**State Historic Preservation Office/Office of Parks, Recreation and Historic Preservation**  
**(NYSHPO/OPRHP) Correspondence Summary**

*Revised January 2022*

**Reference:** South Ripley Solar Project  
Revised Facility Layout  
NYSHPO Project Review # 20PR03687

Map 1. Supplemental Phase IB Archaeological Survey Research Design

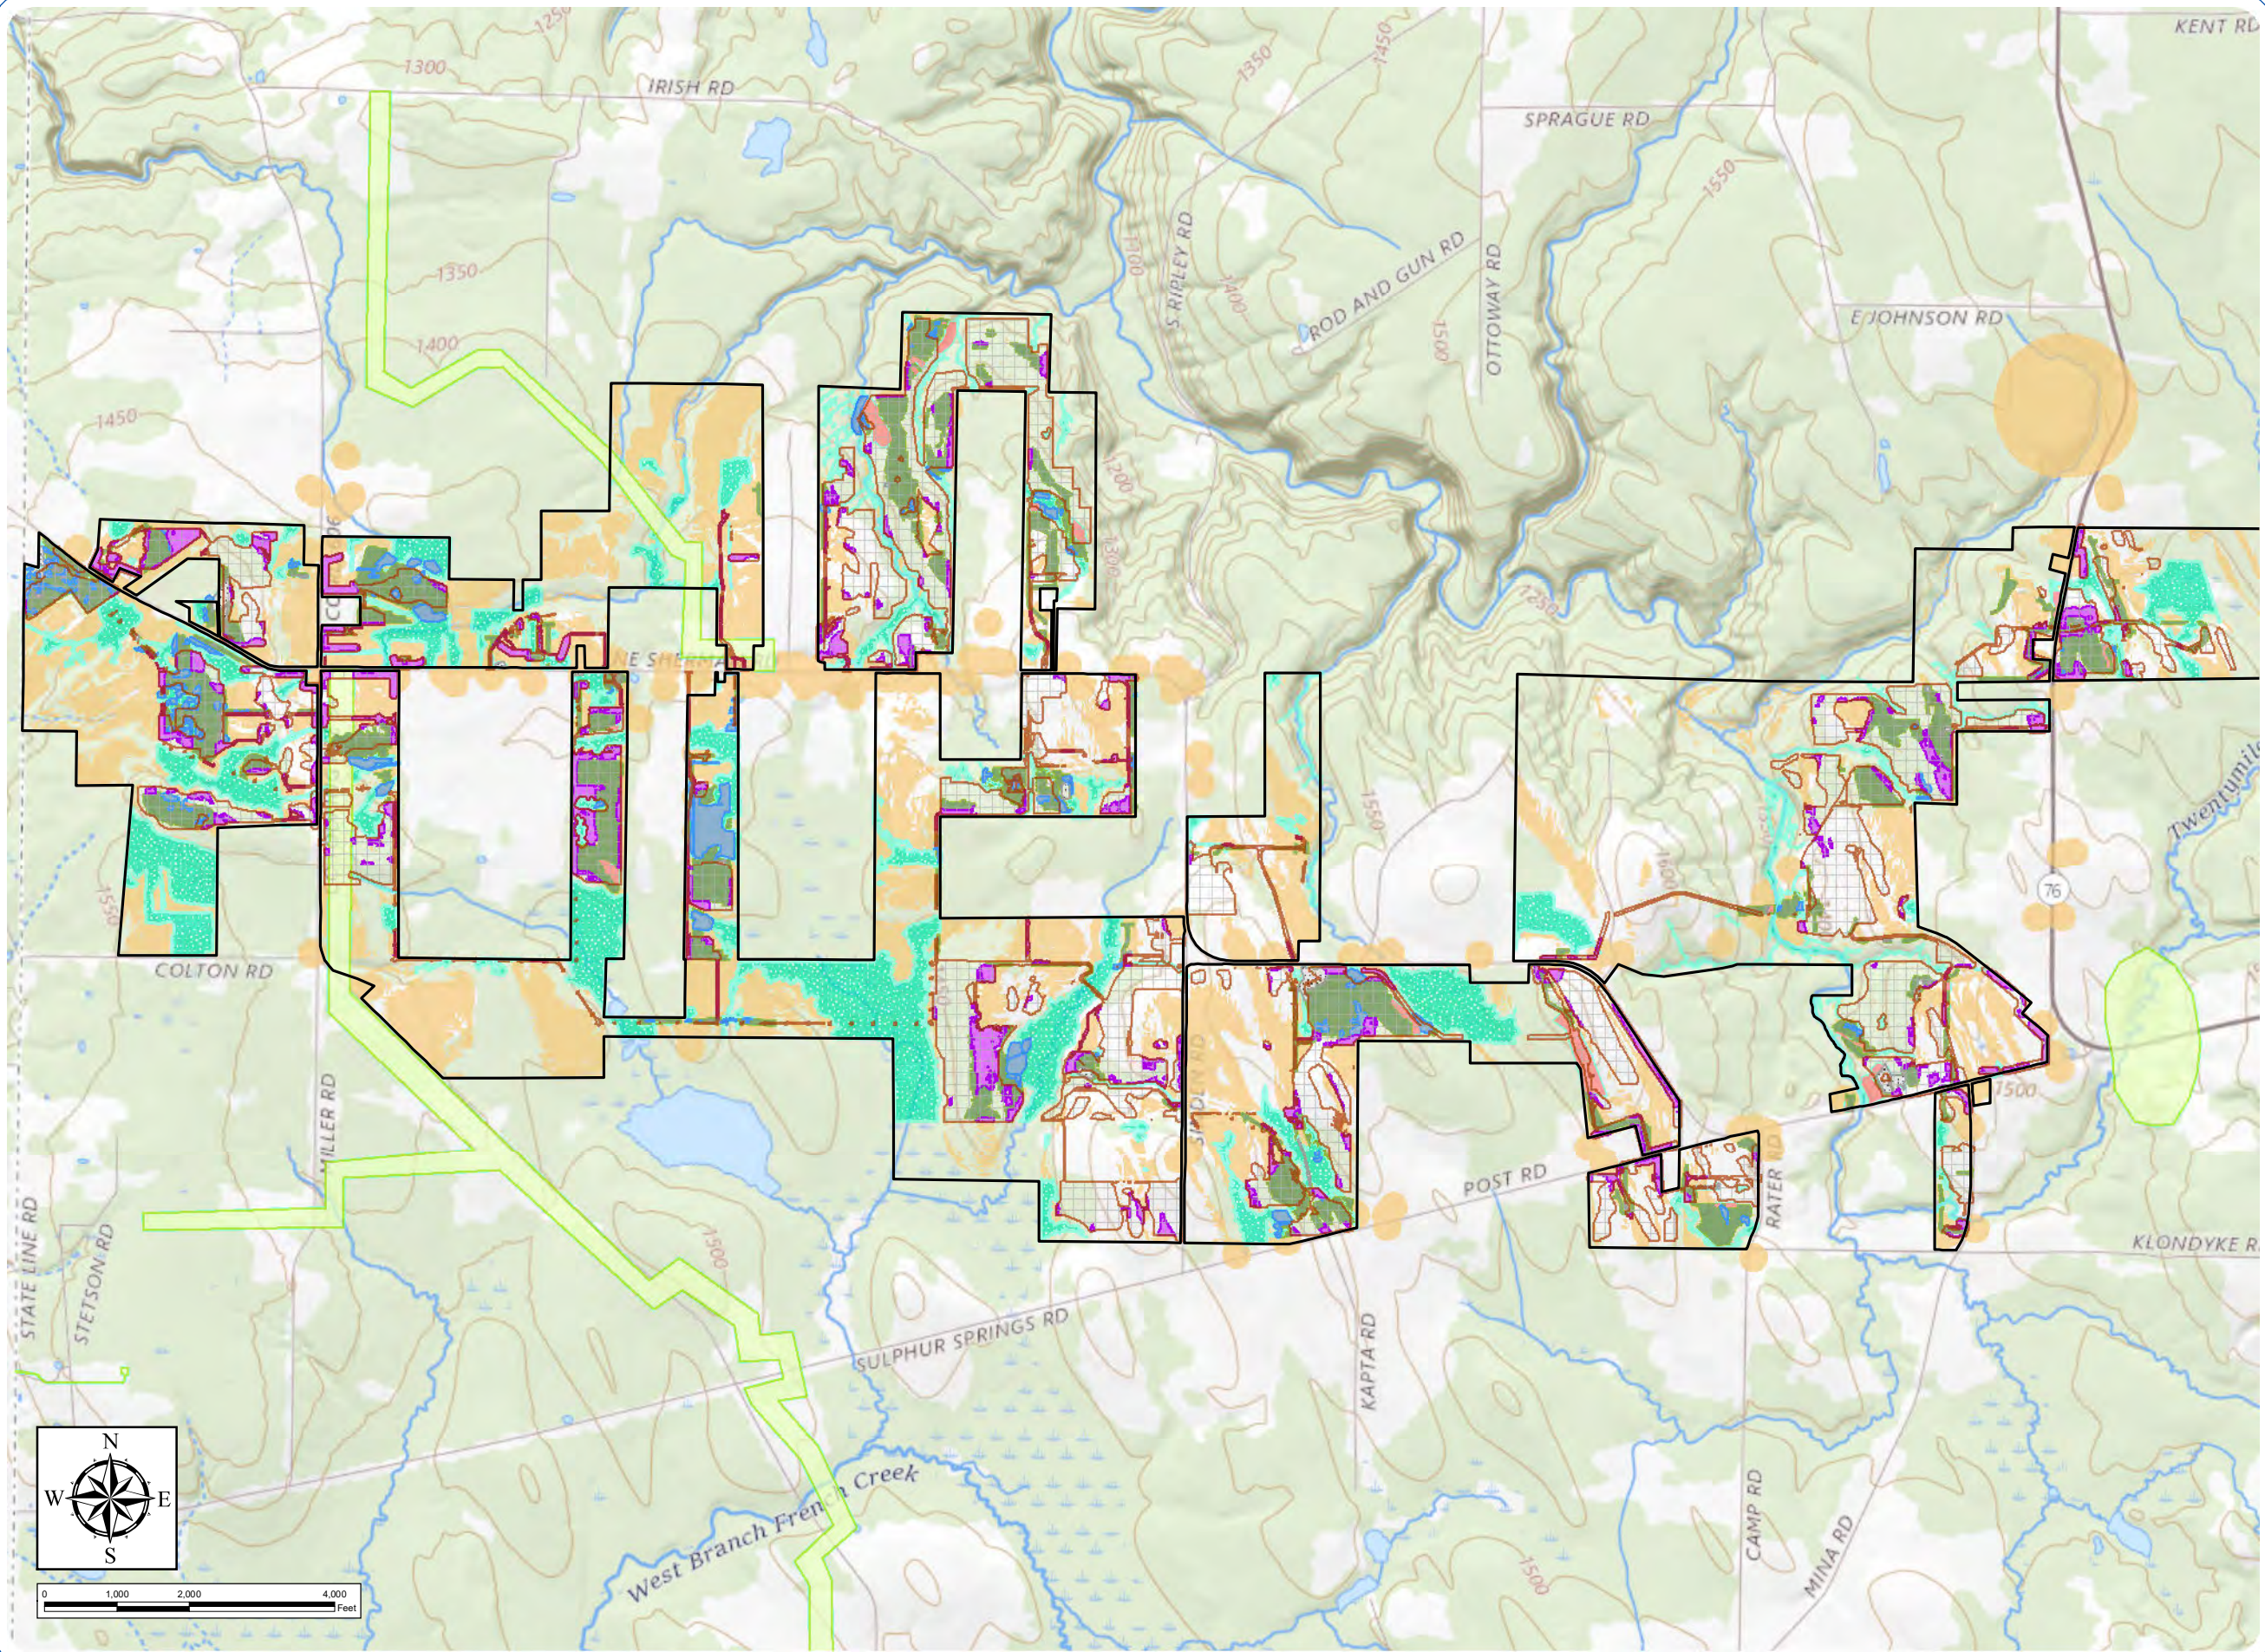
The attached Map shows the revised sensitivity model, limits of proposed substantial ground disturbance (per the revised project layout), areas tested during the prior Phase IB archaeological survey, and remaining areas to be tested in the Supplemental Phase IB survey. The remaining areas to be tested total approximately 110-115 acres.

Based upon our review, OPRHP concurs with the proposed revised scope of work for the Phase IB Addendum survey presented in the above-noted memo (see attached).

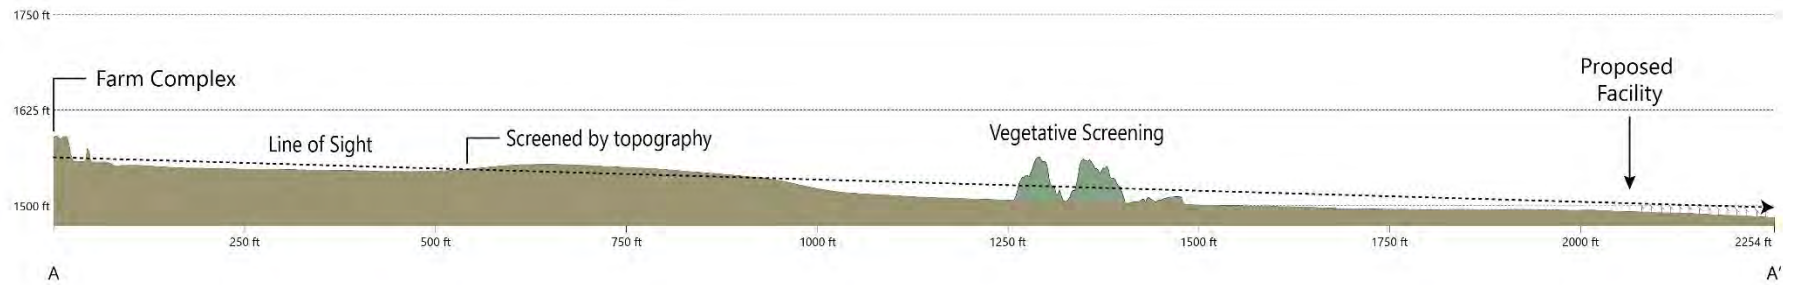
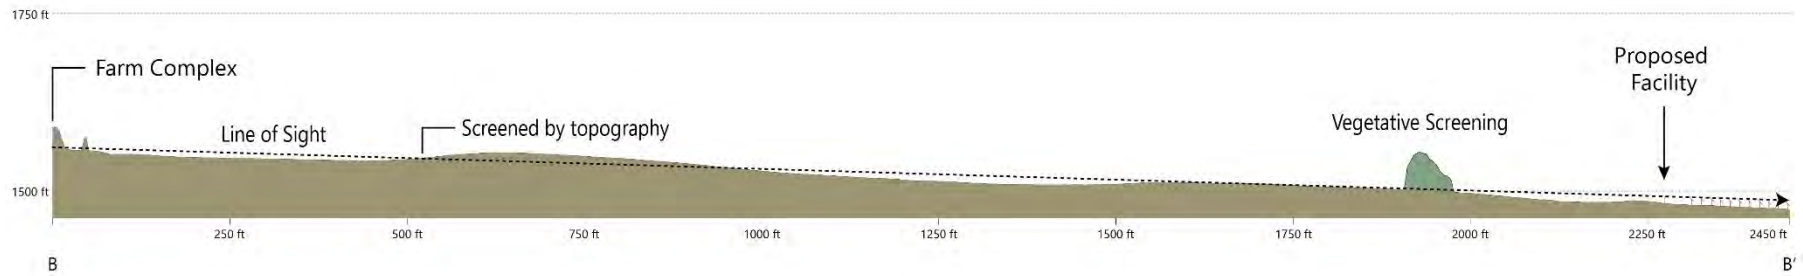
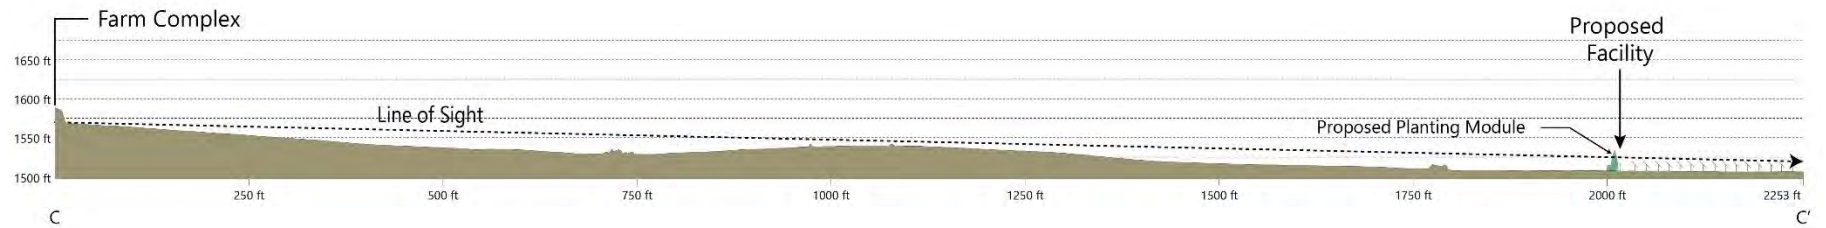
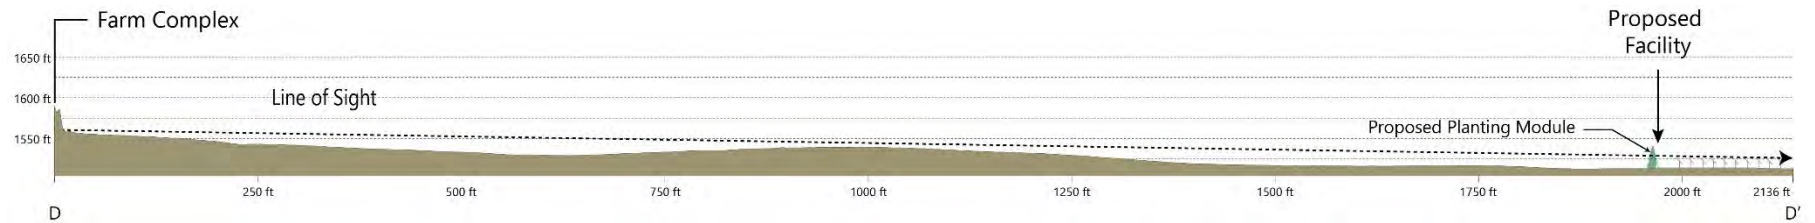
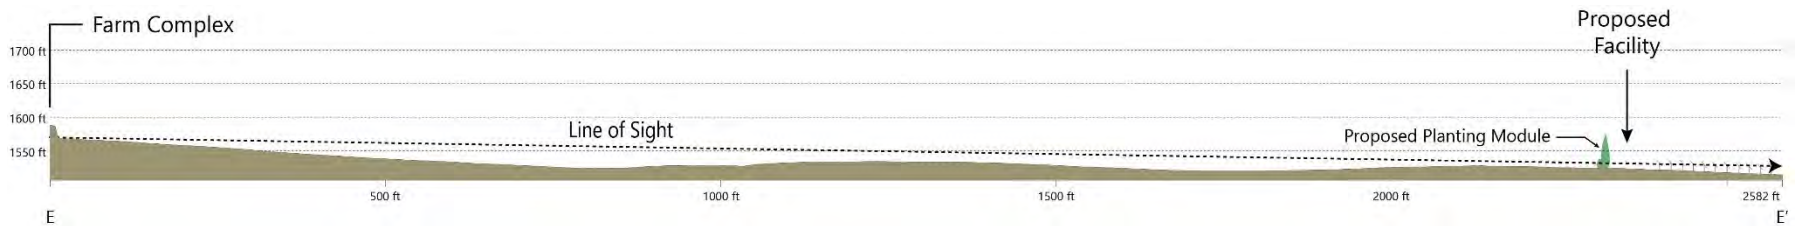
In addition to the findings presented in the VIA, and to further address the extent of potential Facility visibility from the Farm Complex, EDR is providing line-of-sight information regarding the potential degree of visibility and visual impact resulting from the Facility (see Insets 2-7).

The line-of-sight analysis outlined in this memo indicates that the PV Panels proposed to be located west of the Farm Complex will not significantly contribute to the viewshed due to the presence of intervening topography and woodlot vegetation. This condition is illustrated in two line-of-sight cross sections shown below as Section A-A' and Section B-B' (see Insets 3-4). There is a high degree of certainty that this array will be significantly (if not completely) screened from view by topography alone.

An additional three line-of-sight cross sections were prepared to address potential visibility of the PV panel array to the south of the Farm Complex. As illustrated in Section C-C' (see Inset 5), there is a narrow corridor 2,000 feet from the Farm Complex that could provide potential visibility while looking south-southwest. However, this visibility appears to be limited to the uppermost portions of the PV Panels. In addition, this portion of the Facility is proposed to include planting mitigation Module 1, which will provide additional softening of the PV Arrays where visibility may occur.

Line-of-sight Section D-D' (see Inset 6) illustrates a very similar condition to Section C-C'. Again, the Facility is located approximately 2,000 feet from the Farm Complex and visibility is limited to the upper portions of the PV panels due to the presence of intervening topography and vegetation. This portion of the Facility also includes mitigation Module 1 in this location.

Each of the three line-of-sight cross sections illustrating potential visibility of the southern PV Arrays (Sections C-C', D-D', and E-E') also represent a very narrow field of view (approximately 5-10 degrees) toward the Facility. Intervening hedgerows and topography will minimize visibility from lines-of-sight outside of this cone of view. Additionally, the Facility will be further screened from view by a portion of Module 4 mitigation, which extends 780 feet from the northeastern side of the South PV array (see Inset 2).

Based on the information presented in the VIA, the line-of sight illustrations demonstrating the limited visibility from the Farm Complex, and distance from the proposed PV panel arrays (approximately 2000 feet), it can be reasonably expected that the visual contrast and visual impact resulting from the Facility would be commensurately low, if not insignificant. Therefore, it is not anticipated that the Facility will have an adverse impact on the Farm Complex.

Figure 2. Proposed Facility Layout (POI and Substation)

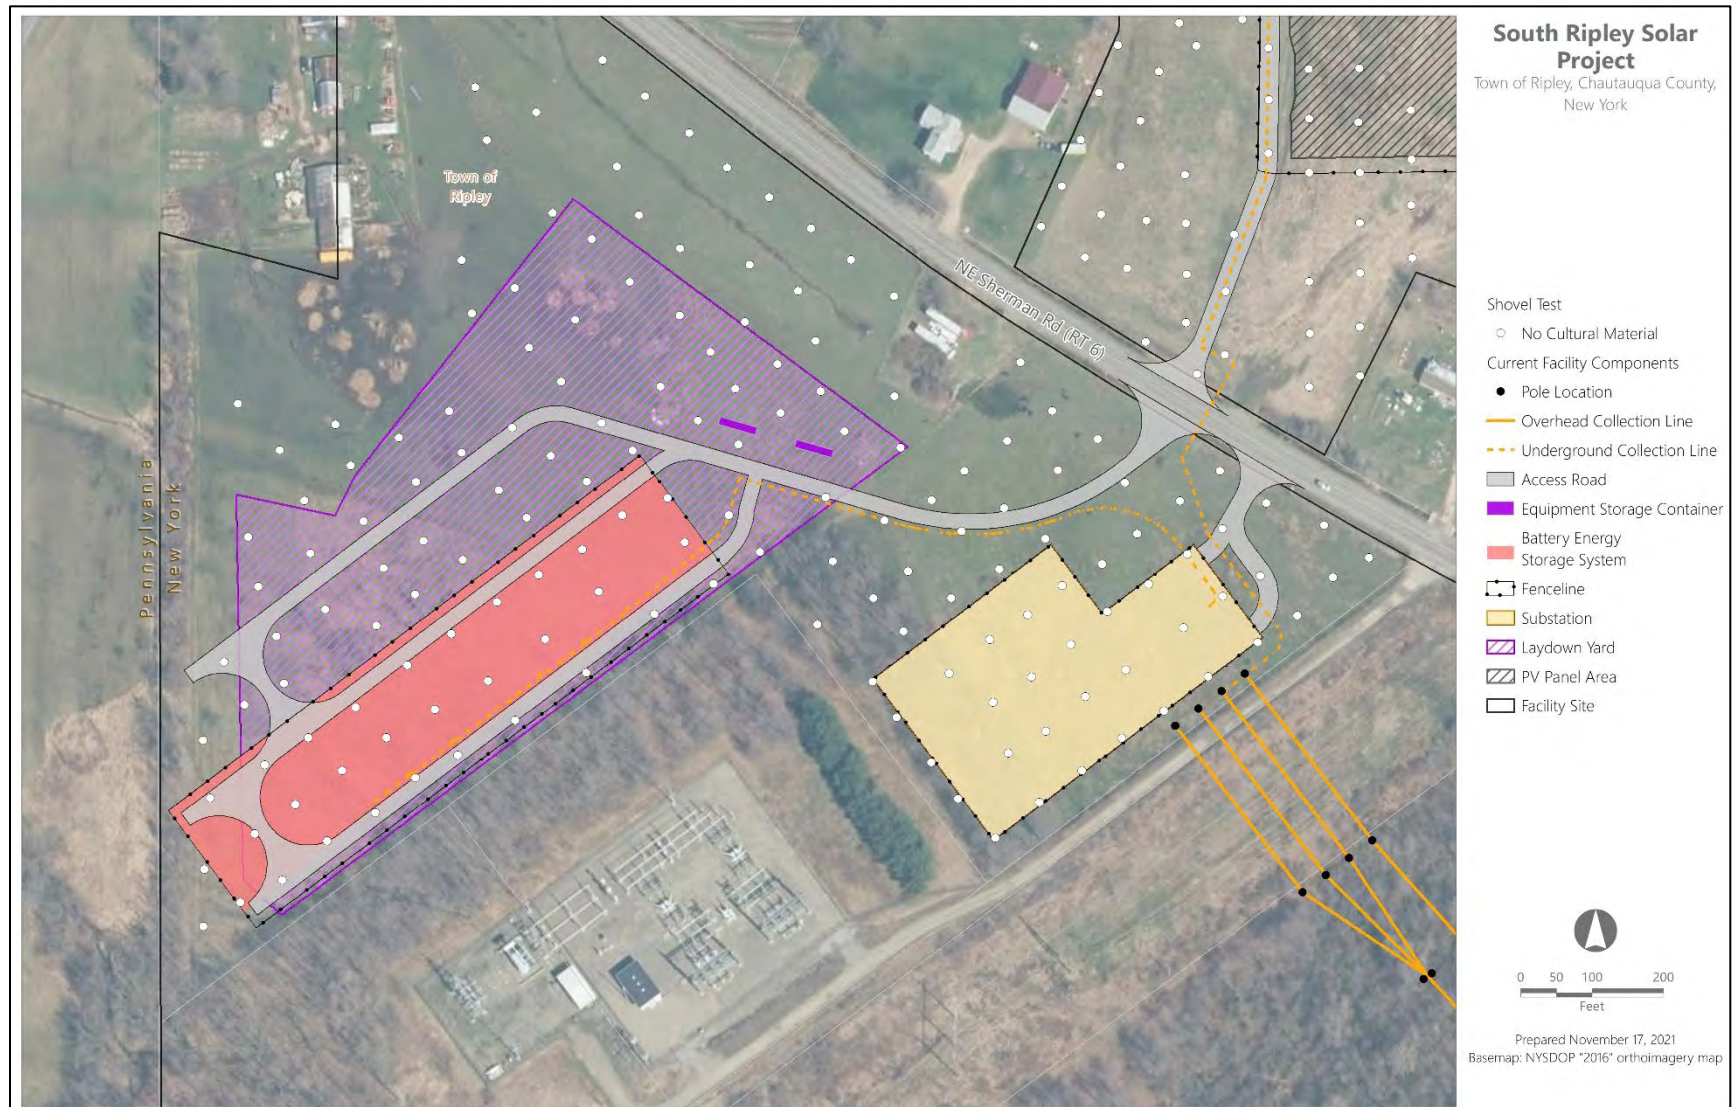
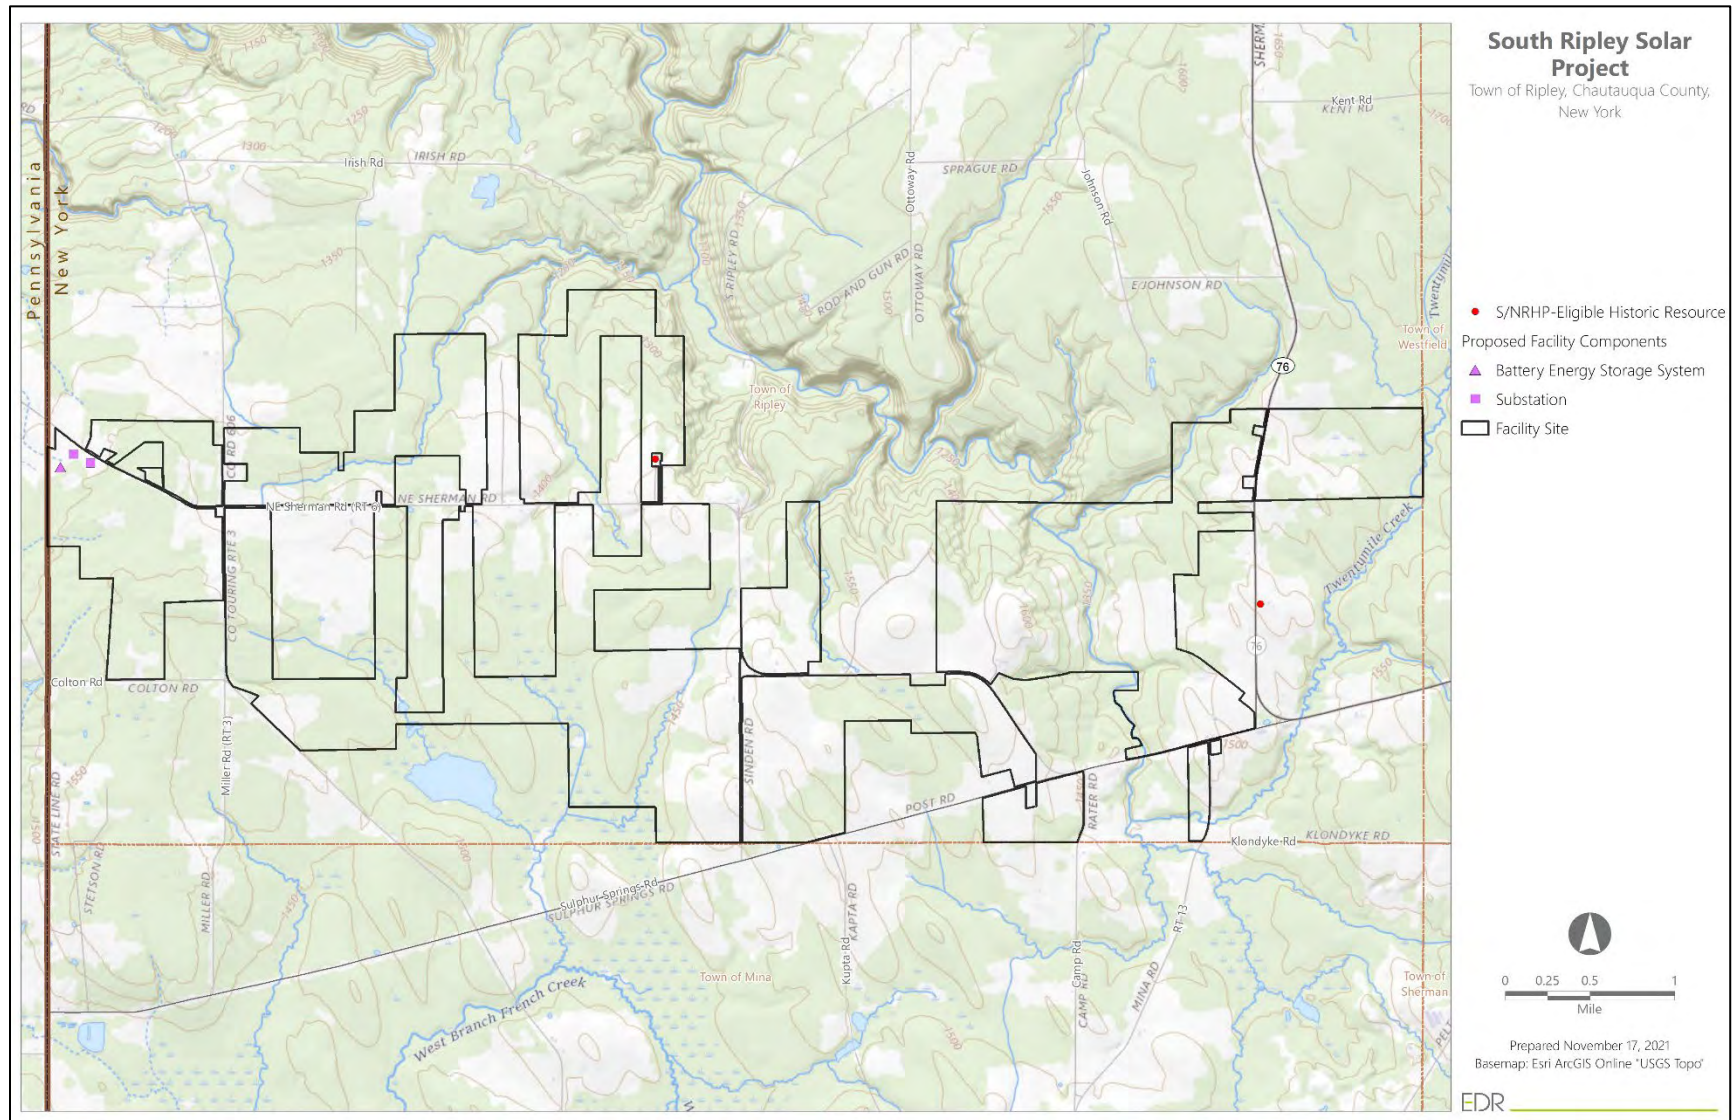
Subsequent to NYSHPO's review of cultural resources surveys for the Facility and finding of No Adverse Impact in September 2021 (NYSHPO, 2021a, 2021b), the Applicant is being required by National Grid and the New York Independent Systems Operators (NYISO) to revise the layout by adding a new stand-alone substation tapping the high voltage line. The new substation will be very similar in size and equipment to the existing National Grid substation. This new POI will be located in the approximate location of the collection substation in the previous design and will have its own access road and fence line. The collection substation will be moved from the originally proposed location in the previous design to north of the Battery Energy Storage System (BESS) and it will tie into a new 3-breaker ring POI rather than the existing National Grid substation. It will contain the same equipment as before, but potentially in a different configuration or arrangement. This will require adjustments to fence line and access roads to both the collection substation and the BESS (see Figure 2).

The proposed revisions to the Facility layout are limited to parcels which have already been surveyed for archaeological resources. These parcels were subjected to shovel testing during the Phase IB archaeological survey, which did not yield any cultural material. None of the 15 archaeological sites identified during Phase IB survey are within or near the parcels affected by the revised layout. Likewise, no previously identified archaeological sites recorded in the NYSHPO Cultural Resources Information System (CRIS) are located within or near these parcels. Therefore, the revised Facility layout is not anticipated to result in any adverse effects on archaeological resources.
